DESIGN REVIEW BOARD
THURSDAY, OCTOBER 1, 2015 6:30 PM

1. 7524 E. Main St.; Application #171387; Carnival Ice Cream; Applicant: Mark Rubcich, DaNite Signs; Signage
2. 1749 Brice Rd.; Application #171413; Westside Graphix; Applicant: Kirk Ramer; Signage
3. 2087 Reynoldsburg-Baltimore Rd.; Application #171528; Bibibop, LLC; Applicant: Tanaya Candella; Signage

**City of Reynoldsburg
Design Review Board
STAFF REPORT
October 1, 2015**

BIBIBOP - STONE CREEK PLAZA

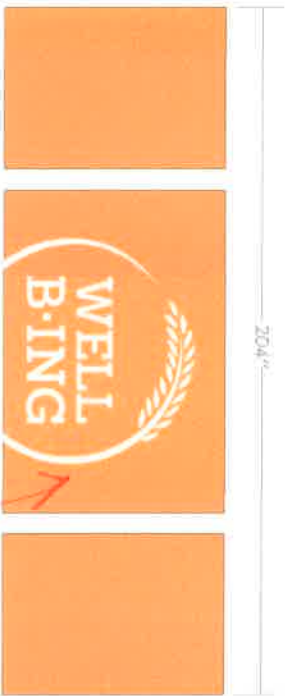
The applicant is proposing to change the materials and building massing of the tenant space to reflect their individual brand. The applicant is proposing to remove two of the false gables on the east facade and replace them with square fascia. Staff is comfortable with this as long as the height of the new fascia do not exceed the height of the remaining false gables.

The applicant is proposing to add an outdoor dining space, which will replace the patio utilized by the previous tenant. The proposed dining space will be defined by a 3' black wrought-iron railing around its perimeter. Staff feels this will be an improvement over the current wood privacy fence.

The applicant is proposing to utilize some existing stucco, wood siding, brick and stone for the facade modifications. The applicant is also proposing to utilize some orange ECB sign board panels for signage and color accent. Although there are no specific design or material guidelines for this location, Staff is comfortable that the materials presented are consistent with the quality of materials of buildings in the surrounding area and within minimum standards for new commercial buildings presented to the Board for properties in the Community Commercial Overlay District.

Staff recommends that the Board apply the standards for design review and determine if the proposed modifications enhance the character of this commercial corridor. Staff recommends approval of the certificate of appropriateness.
